# **AMENDMENTS TO THE DRAWINGS:**

#### **REMARKS**

#### II. THE DRAWING OBJECTIONS

FIG. 3

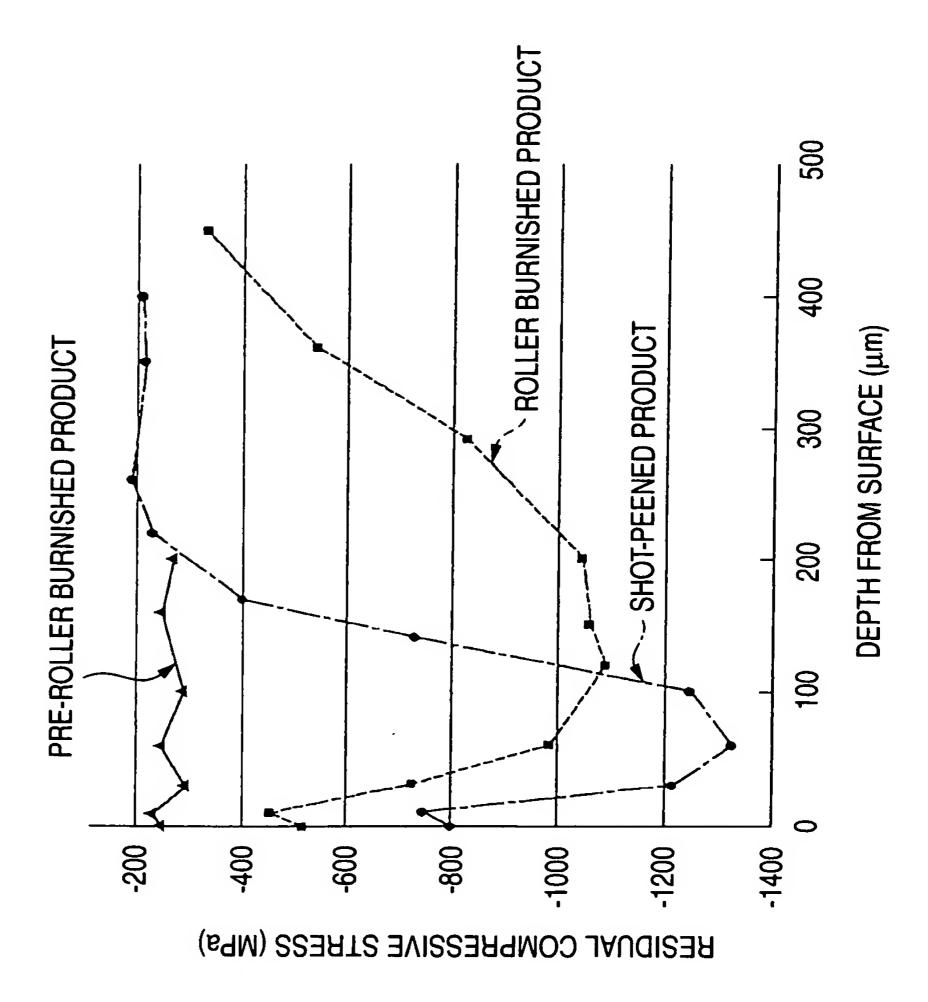
The Office Action objects to Figure 3 because that figure "does not make sense." In this regard, Applicants thank Examiner Binda for the courtesies extended during a telephone conference on February 21, 2006, where Examiner Binda explained his concerns regarding Figure 3.

The Examiner also objected to Figure 3 for not showing a residual compressive stress as being larger than 800 MPa at depths of at least 0.3 mm as described by the specification at page 11, lines 8+ and page 12, lines 22+. In this regard, this Amendment amends the specification to more clearly describe that the residual compressive stress is larger than 800 MPa at a depth of up to 0.3 mm. Applicants respectfully request withdrawal of this objection.

Corrections have been made per Examiner's Suggestions,

The attached sheet of drawings includes changes to Figure 3. This sheet, which includes Figure 3, replaces the original sheet including Figure 3. In Figure 3, the graph has been corrected to correspond with common graph conventions in accordance with Examiner Binda's very helpful suggestions.

In response to Examiner Binda's very helpful suggestions, this Amendment encloses a replacement drawing sheet which corrects Figure 3 to comply with recognized conventions regarding representing a residual compressive stress which increases as corresponding to an increase in the distance along the Y- axis from the origin, to provide the legends for the X-axis along the X-axis, and to correctly show the X-axis as extending from the origin of the graph. Applicants respectfully request withdrawal of this objection.
